Inspection Report

Permit Number:	C0070039
Inspection Type:	PARTIAL
Inspection Date:	Tuesday, August 20, 2013
Start Date/Time:	8/20/2013 7:00:00 AM
End Date/Time:	8/20/2013 3:30:00 PM
Last Inspection:	Tuesday, August 06, 2013

Site: **DUGOUT CANYON MINE**

On August 20th, 2013, Division of Oil, Gas and Mining staff (the Division) conducted a field inspection of the gob gas vent hole sites (the sites) at the Dugout Canyon Mine. The purpose of the field inspection was to document the condition of the sites and associated access roads and to inspect recently initiated/completed reclamation work. Overall, the condition of the degas sites (both reclaimed and un-reclaimed) was very good. No evidence of off-site impacts was observed during the field inspection. Some minor maintenance work is required on the skid road to degas pad G-19 and on the AMV Road's water bar (See discussion below).

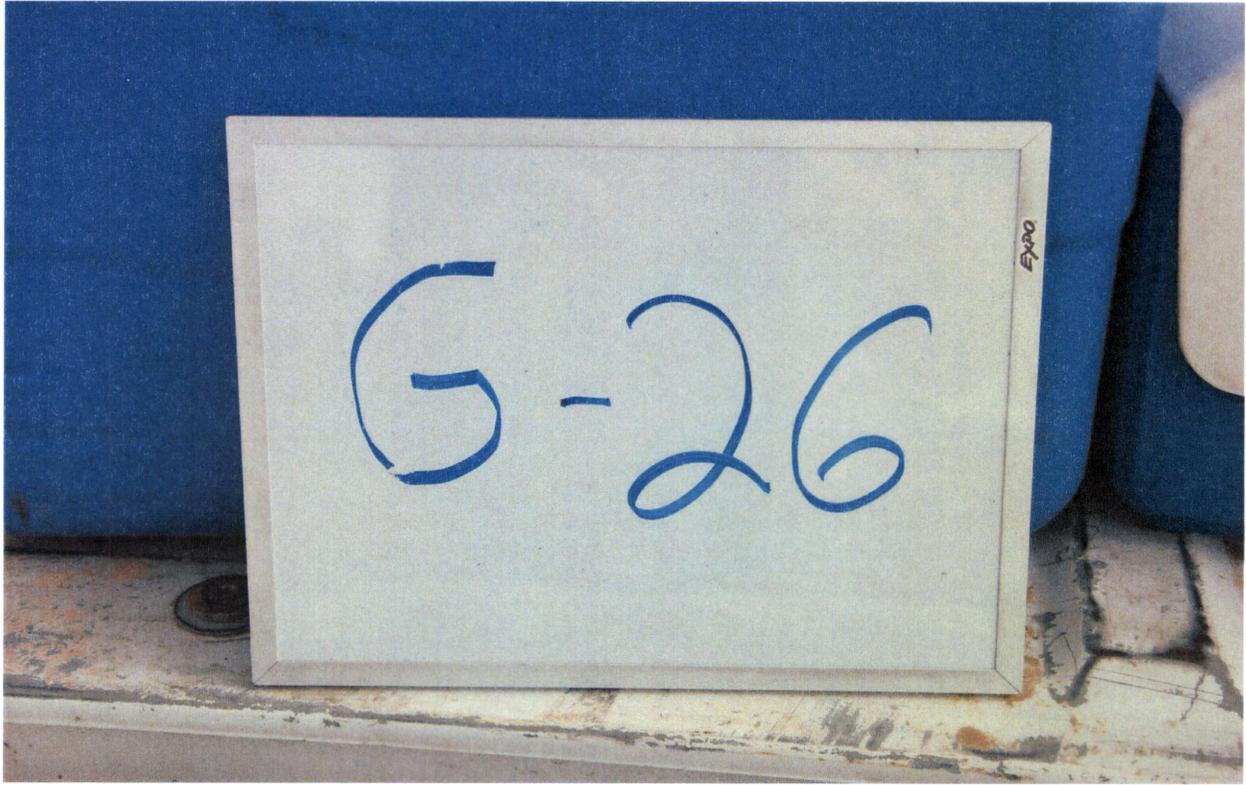
Site 22 was being graded. A dozer was lifting material from the outslope in 5 ft. increments. The topsoil for this site is stored at site G 17.

Pre-existing skid road to Site G-19

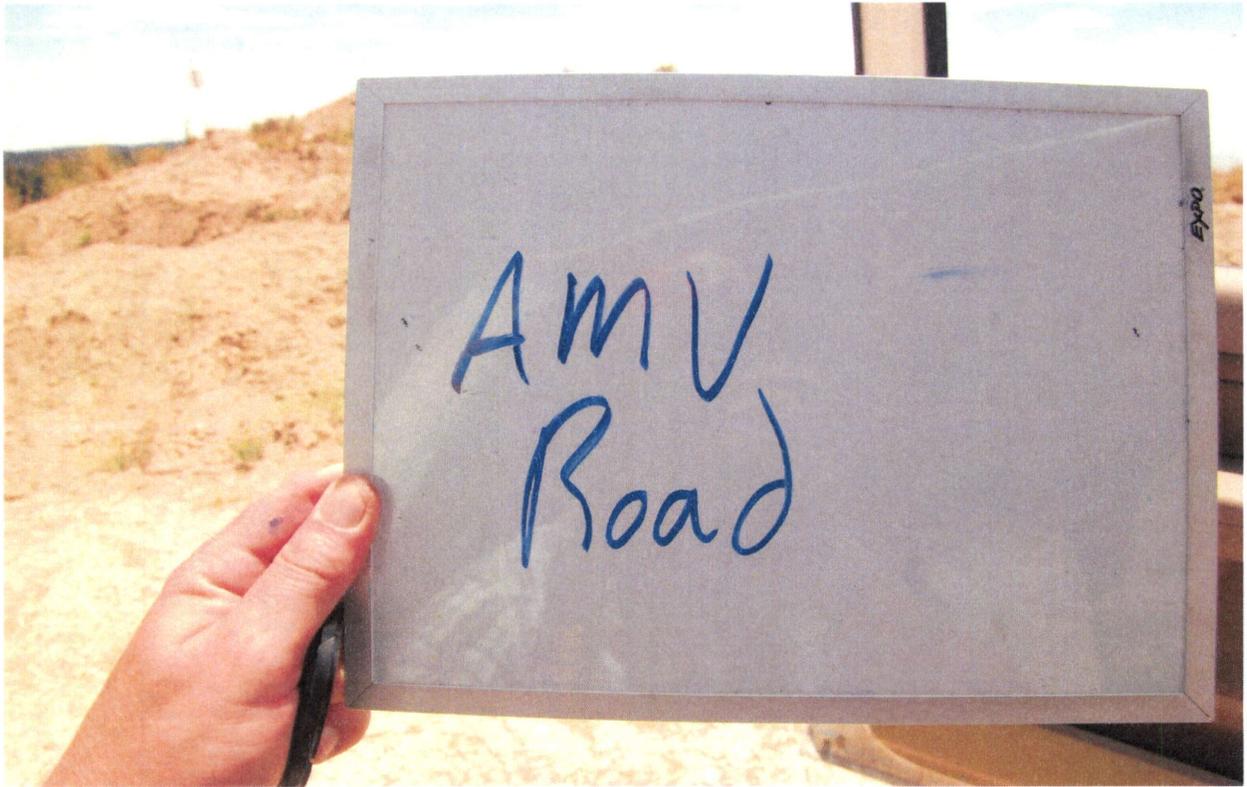
G-19: The site was reclaimed during the 2012 construction season. The pre-existing skid road was observed during the inspection. Evidence of erosion on the skid road was observed during this inspection. It should be noted that erosion concerns were noted during the 2012 inspection. In response, the Permittee installed a series of water bars along the entire slope of the skid road to reduce storm flow velocities. However; a fairly significant rill/gully has begun to form in the upper portion of the skid road (See photo). The gully was approximately 10"-12" in places. It was discussed with the Permittee that additional sediment control measures would be needed. It was discussed that placing excelsior logs perpendicular to the flow direction at intervals along the eroding skid road areas would be a prudent measure. As with the AMV road, it was recommended to the Permittee to install excelsior logs at the outlets of the water bars in order to prevent sediment from flowing off the disturbed area during rainfall events. The pad at G-19 (both above and below the skid road)

Site G-17

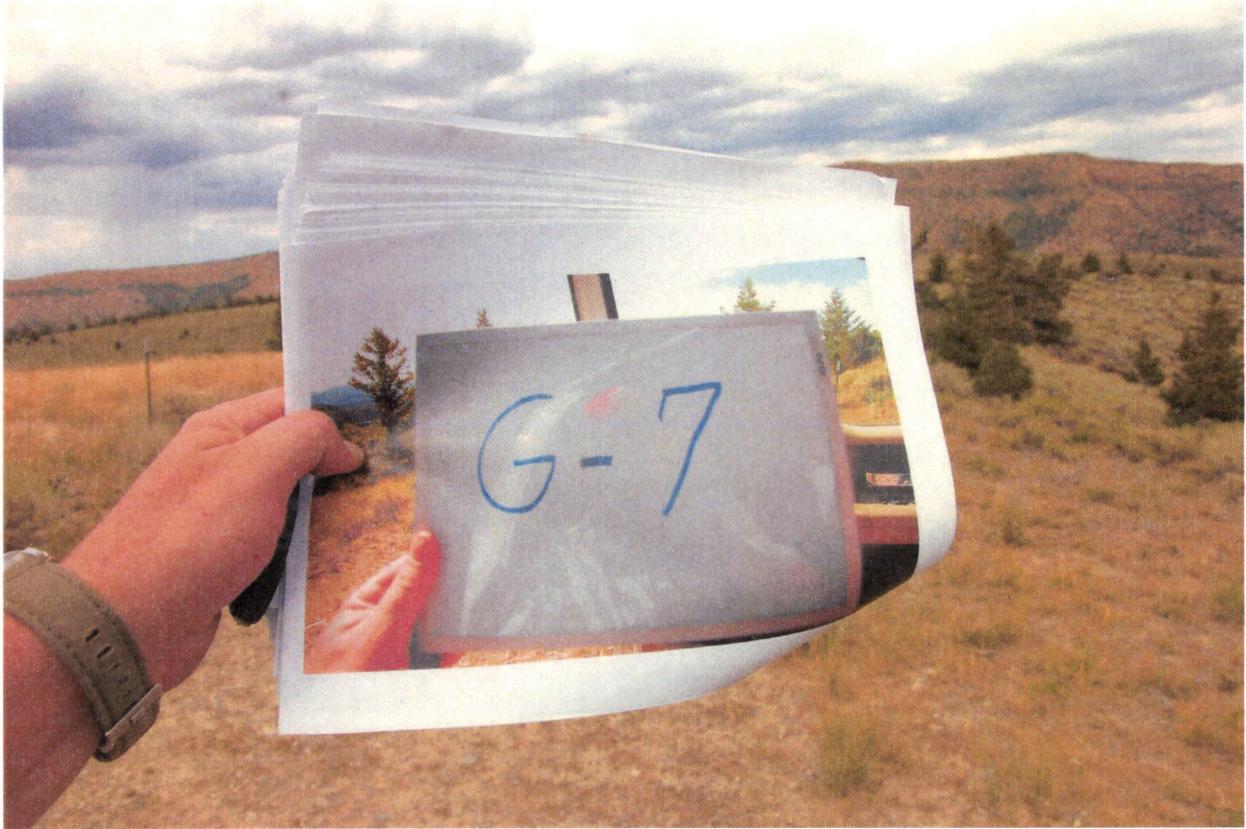
G-17: The site is being utilized as a top soil storage area. Top soil from Site G-22 and its access road are stored here. Once site G-22 is reclaimed, this area should be reclaimed as soon as possible.
